81133A-01

S E R V I C E N O T E

81133A- High Speed Pulse Generator

Serial Numbers: DE42800001-DE42800314

MOTHERBOARD
BACK SIDE VIEW

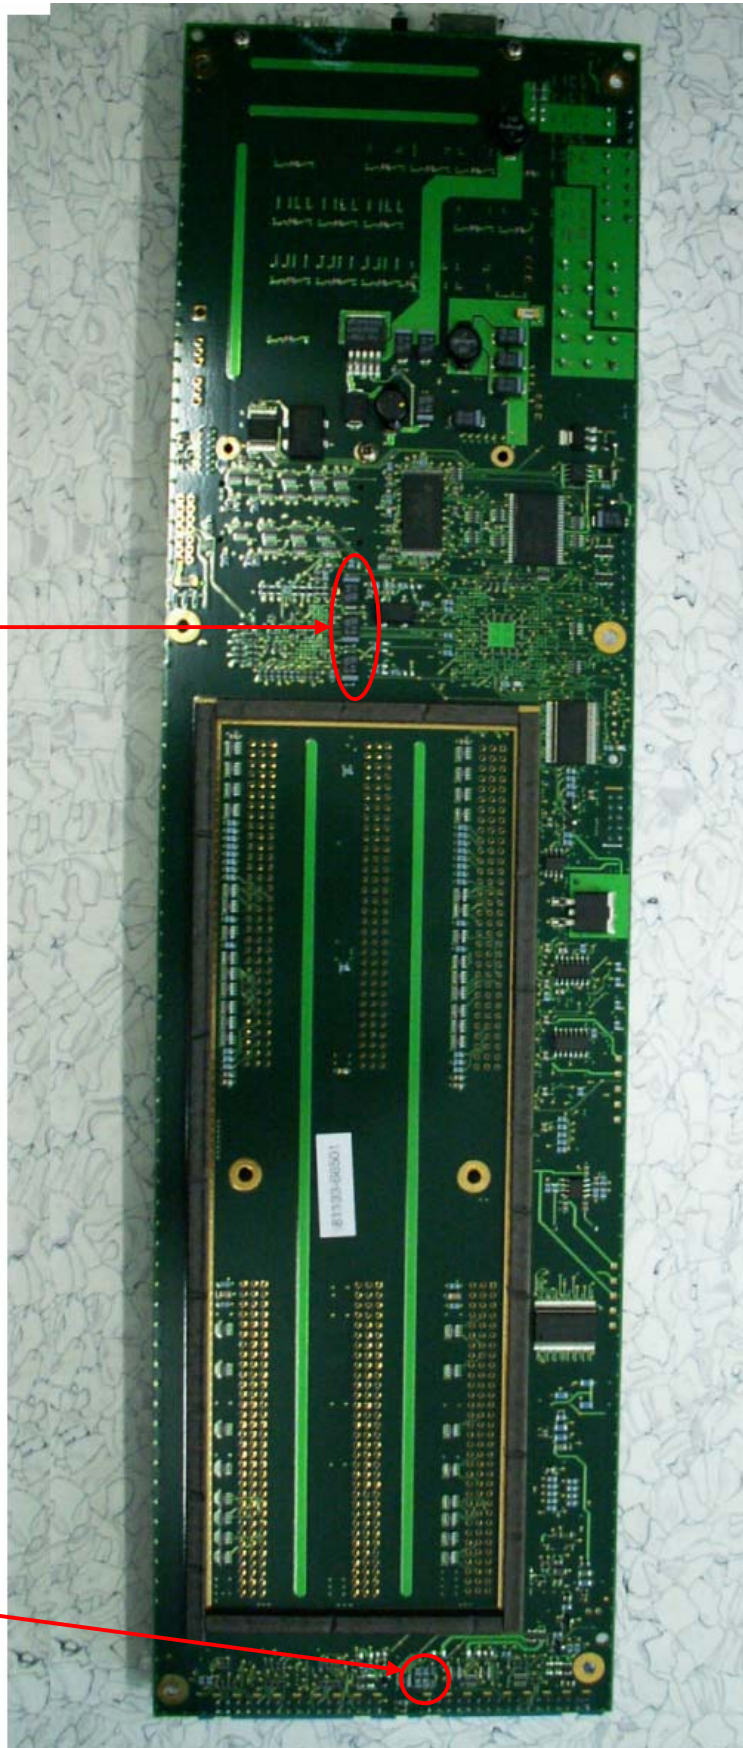
The preventive maintenance to avoid flickering display failures requires removing the 3 capacitors shown in the following picture and replacing them with new capacitors (part number 0180-4758) while mounting them with the correct polarity.

Polarized Capacitors

Extra Resistors

CLOSE UP VIEW WHERE THE CAPACITORS ARE LOCATED

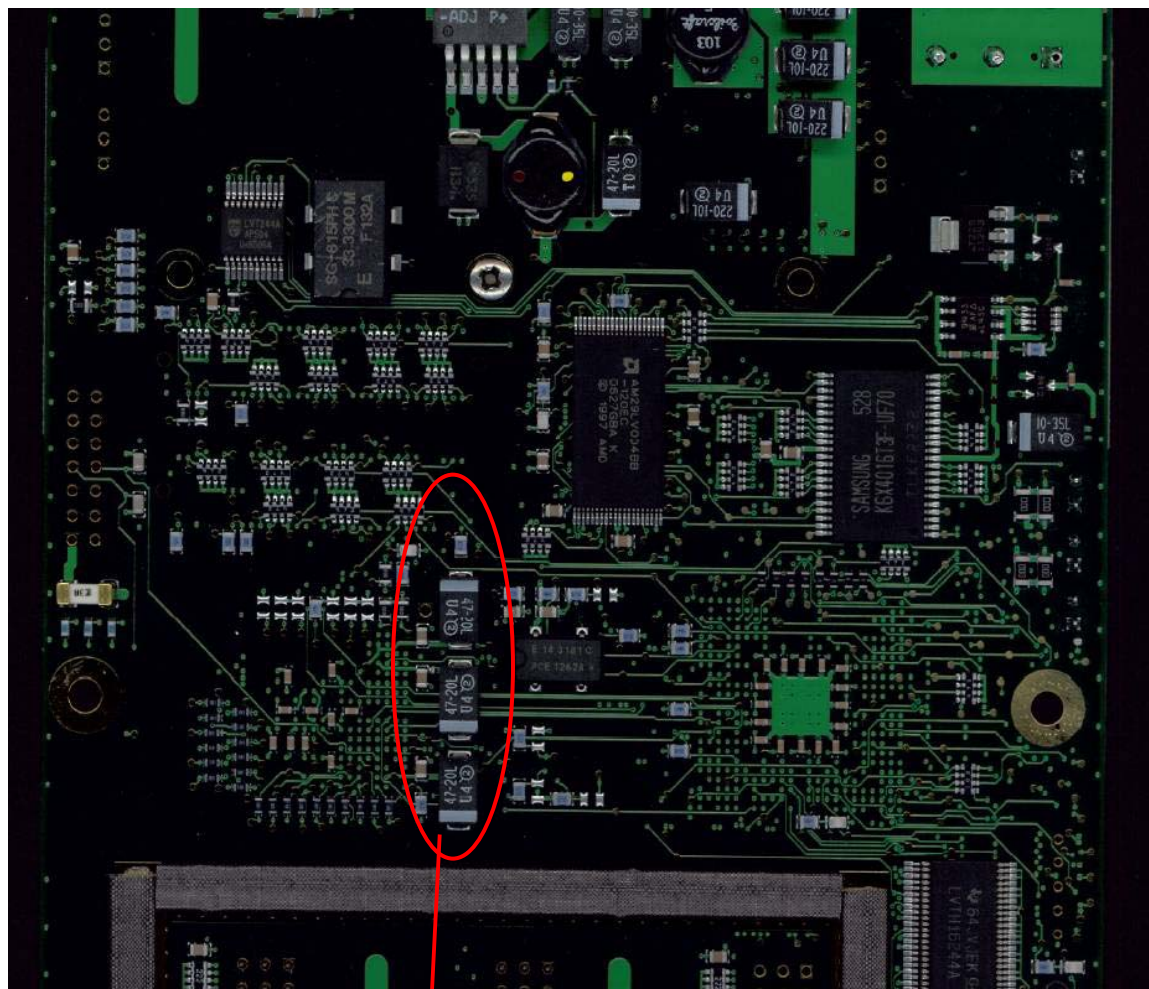
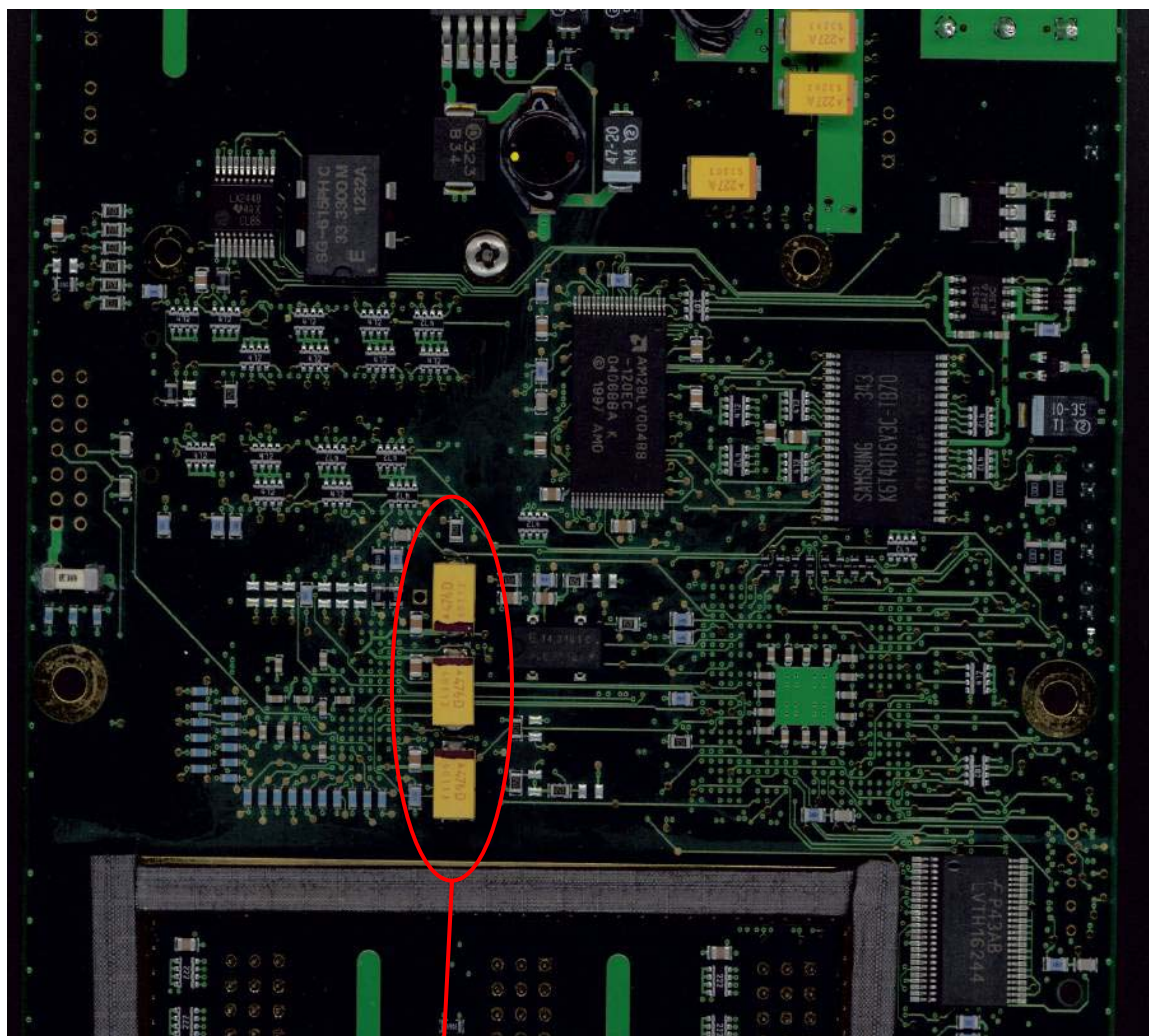
Three polarized tantalum capacitors on the motherboard are connected with the wrong polarity. The polarized tantalum capacitors are normally more sensitive than others, so they tend to fail after some months. Due to this, wrong voltages were delivered to the front panel board which in turn affected the display.

Capacitors mounted with the wrong polarity. The positive side is shown with the white/grey stripe. These 3 capacitors need to be removed.

By applying new capacitors and mounting them with the right polarity failures can be prevented for the future.

This photo shows the capacitors mounted with the right polarity. The positive side is shown with the black stripe. The colors might vary.

CLOSE UP VIEW – THE RESISTORS ARE REMOVED

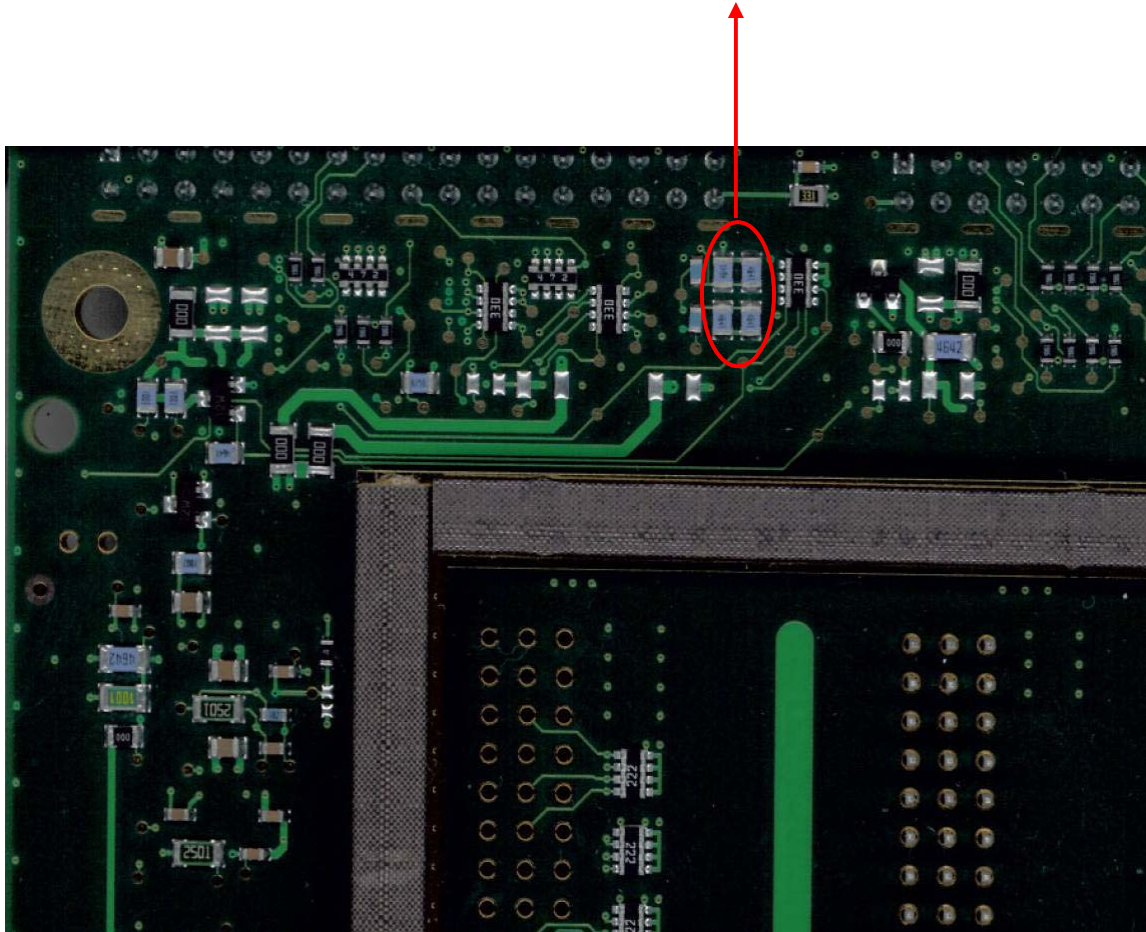
The rotary encoder (APN 0960-1055) has failed in some cases due to incorrect pull up resistance of the encoder. The pull-up resistance of this encoder as specified by the manufacturer is minimum 2.2 K Ohms. According to the schematic of the front panel in the 81133A, the pull-up resistance used was 1.5 K Ohms. The lesser resistance value had possibly led to the flow of more currents into the encoder and had degraded the performance of it over a period of time.

For the preventive maintenance of the know problem the following 4 resistors need to be removed. They are best removed using hot air.

Resistors to be removed (The colours can be different)

By removing a few parallel resistors the resistance can be increased, preventing failures of the rotary encoder in the future.

The place where the 4 resistors are removed
